E3

NO.	DATE	REVISION	BY
⚠	2-10-98	ADDENDUM 2	JJK

TOWN OF ADDISON, TEXAS

CELESTIAL ROAD PUMP STATION ADDITIONS
ELECTRICAL SCHEMATICS I

04 CONTROL SCHEMATIC – MODIFIED EF–1 & EF–3

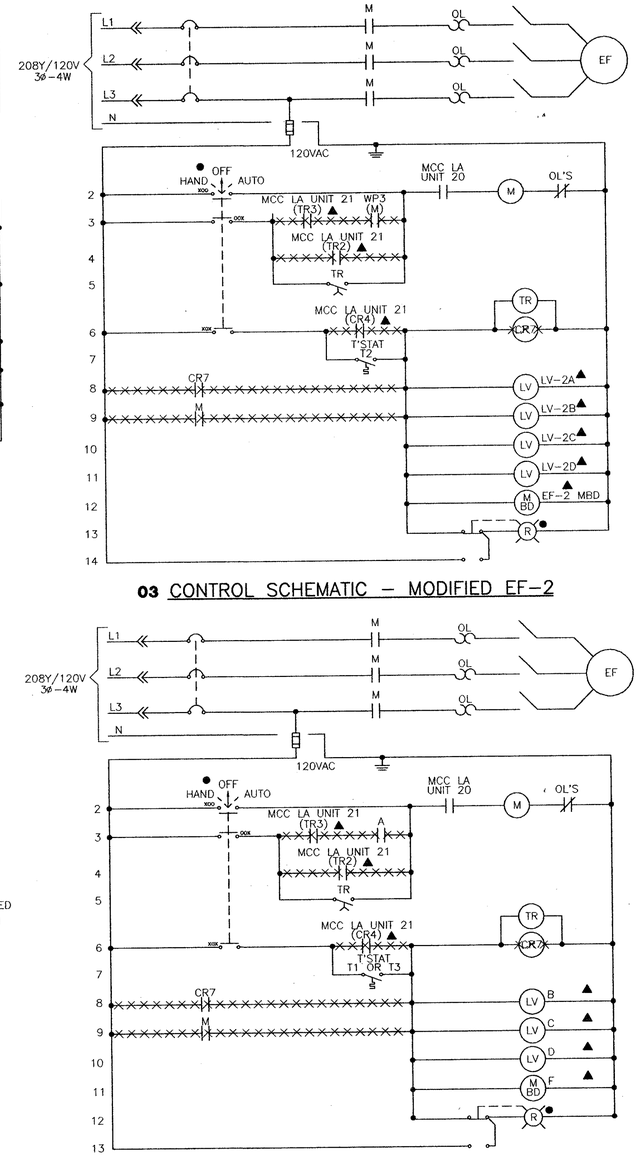
1. MODIFY CONTROL CIRCUITS FOR EF–1,2&3. STARTER UNTIS ARE LOCATED IN MCC–LA. ADD THERMOSTATS AND WIRING AS SHOWN ON PLAN VIEW.
